REMARKS

AMENDMENT

IN THE DRAWING

FIG. 4

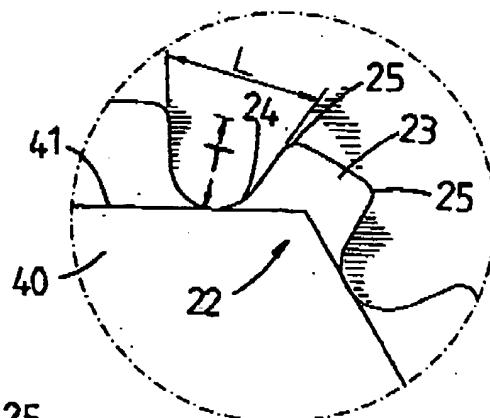
About the definition of the length L and T are amended in above amendment of the specification based on those illustrated in Fig. 4 of the present invention.

The amended Fig. 4 sent at Oct. 20, 2004 is amended (restored, namely, the amendment at Oct. 20, 2004 is not used) to be identical to the original copy. That is, all the drawings are identical to the original ones. No new matter is added.
